Planning Rationale Addendum Report

## Laurelpark Estates – Fourth Submission

### Draft Plan of Subdivision and Zoning By-law Amendment

Prepared for Laurelpark Inc.  
by IBI Group  
December 15, 2020

Figure 1: Draft Plan of Subdivision

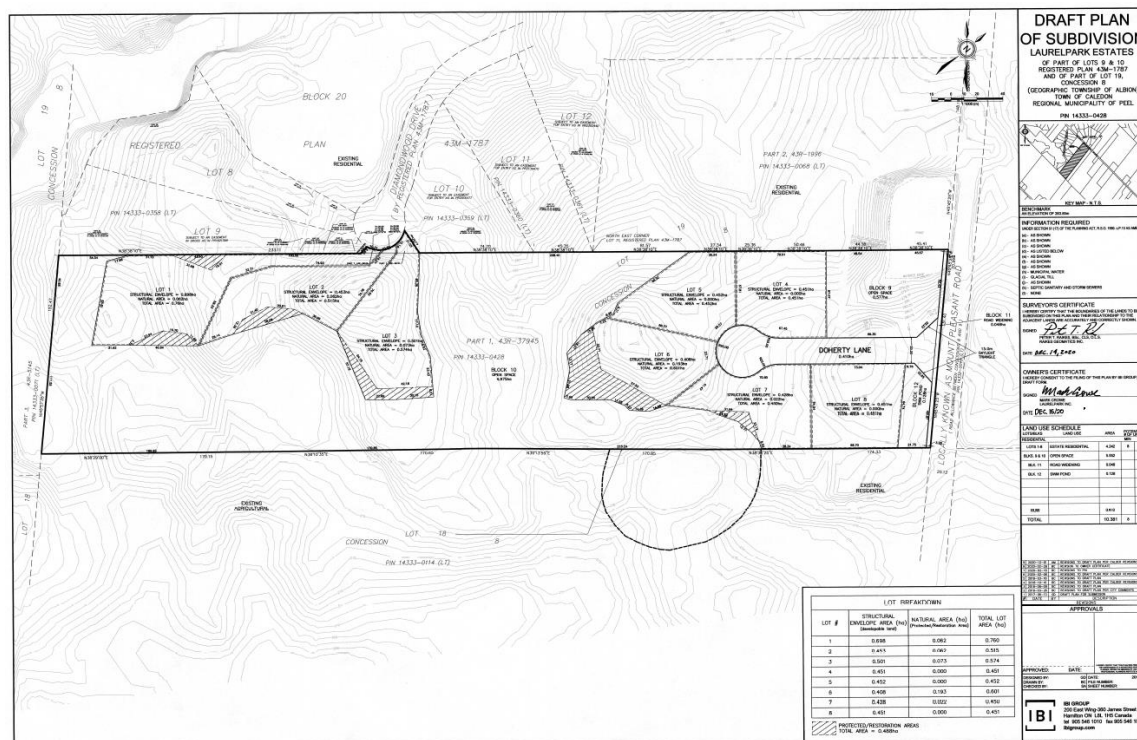
- a. *Amend the Environmental Summary Map to identify Policy Area 4.*
  - b. *Amend the draft plan to incorporate Block 11 into Lot 1.*
  - c. *Amend the draft Zoning By-law Amendment to rezone the limits of Block 11 as Environmental Policy Area 1 – Oak Ridges Moraine – Exception XX (EPA1-ORM-XX), containing a natural area restriction.*

The following minor changes were applied to the previous version of the Draft Plan of Subdivision to address staff comments and concerns:

- Minor adjustments to the lot line configuration between Lots 1-3 to regularize the lots;
- Redefined Structure Envelope and Natural Area for Lots 1-3 to compensate for new lot configurations;
- Block 11 is now incorporated within Lot 1;
- Updated Lot Breakdown Chart and Land Use Schedule in accordance with minor lot line, Structure Envelope, and Natural Area revisions;
- Tivoli Circle is now referred to as Doherty Lane;
- PIN number revised;
- Legal description revised; and,
- Signed Owner and Surveyor Certificates.

**Figure 2:** Revised Lots 1-3

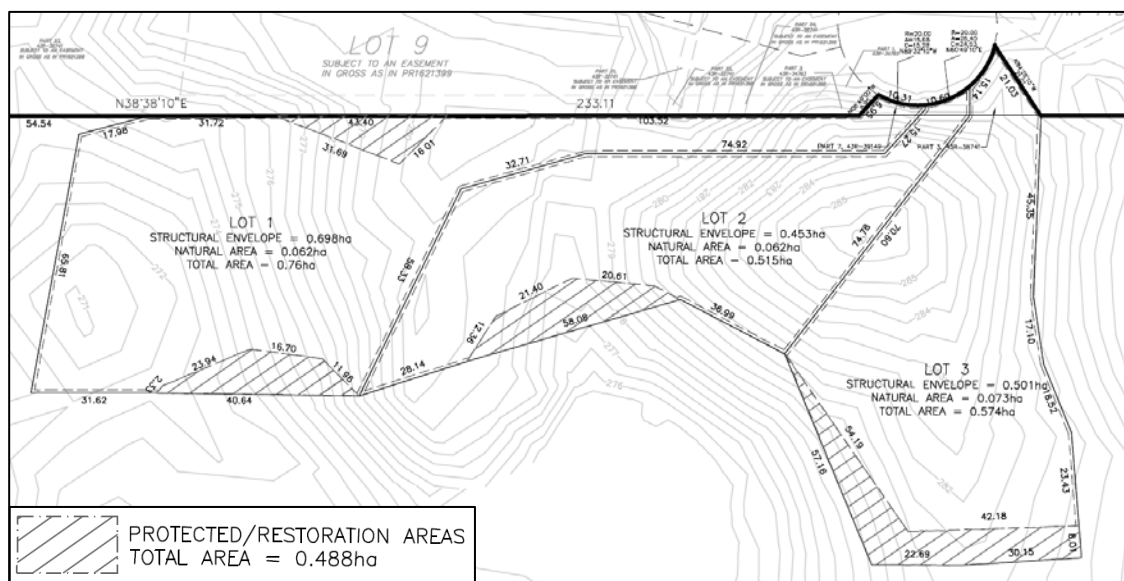
- *Please also review the boundaries of the lots and structure envelopes to create uniform boundaries to the best of your ability, while still meeting the planning policy context.*
- *Staff request that the useable area (comment #11 below) is identified on the Environmental Summary Map.*
- *Please ensure that all dwelling footprints shown on the Environmental Summary Map are a minimum of 400 sq. metres in size.*
- *Staff will also require warning clauses noting all of these restrictions in the Agreements of Purchase and Sale.*

**Planning Response:** The lot lines between Lot 1, 2, and 3 have been revised to create more regularized lots, as shown in **Figure 2** below. Moreover, the mutual easement boundaries no longer exist, as separate driveways are now proposed for Lot 1 and 2. Please note that the minimum Lot Area of 0.45 ha is still being maintained and the proposal is still in conformity with Policy 7.1.9.11 and Policy 7.1.9.41 of the Town of Caledon Official Plan, further discussed and justified in Section 5 of this report.

**Figure 3:** Revised Proposed Driveway Configuration for Lots 1-3

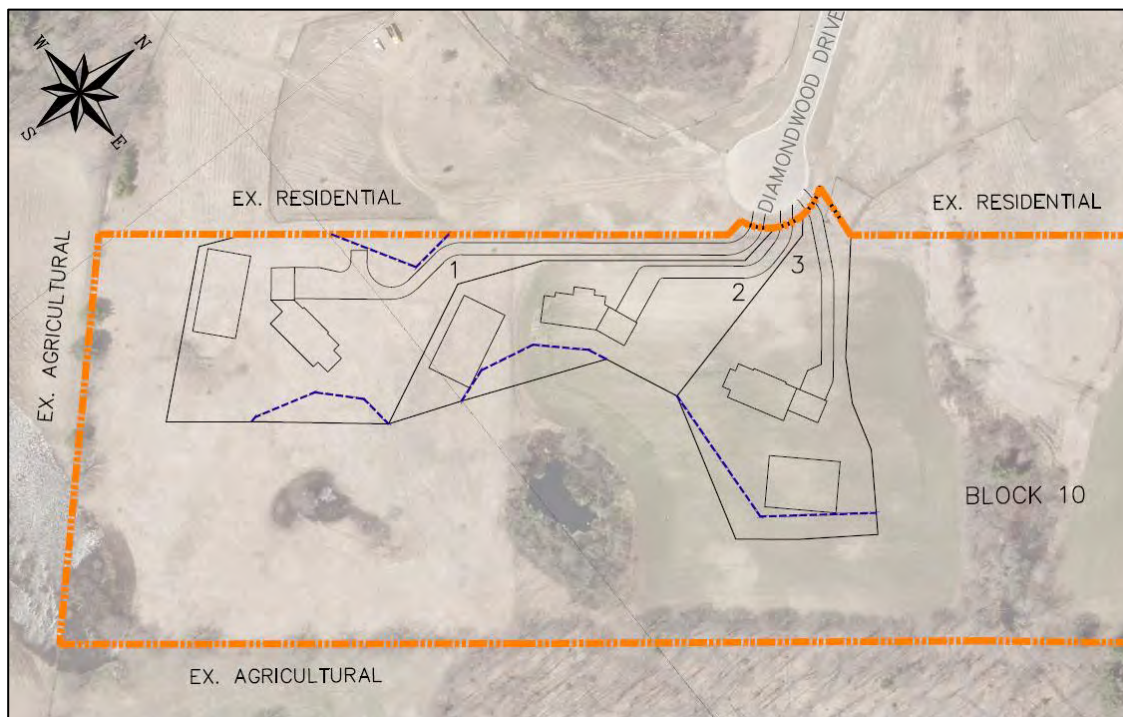
4. Town staff are not in support of a minimum parking area setback of 2.5 m on Lot 1. Staff believes that this request is made for the hammerhead to assist with a turnaround, and if this is the case, then this setback may not be required due to the proposed Town initiated Zoning By-law Amendment clarifying driveways. Staff has not included an amendment to driveway width in the attached version of the draft Zoning By-law. Should there be concerns with this approach, please advise. (Community Services, Planning and Development Services, Planning and Zoning)

**Planning Response:** A maximum driveway width of 12.5 metres is no longer proposed. Initially, this regulation was proposed to permit the shared driveway for Lots 1 and 2. The following drawing is for illustrative purposes to demonstrate the revised driveway layouts. They can be further refined through the Site Plan stage of the planning process as long as they continue to maintain the intent of the Town of Caledon Official Plan, including Policy 7.1.9.4.

The average driveway width proposed is 4.5 metres; however, the proposed driveway width at its widest point where it provides direct access to a private garage is 11.5 metres (Lot 1). Therefore, *Regulation 5.2.15 Width of Driveways Accessing Individual Residential Dwellings* that permits a maximum driveway width on the subject lands of 6 metres shall be amended accordingly. The Town should advise if their proposed Zoning By-law Amendment suggests otherwise.
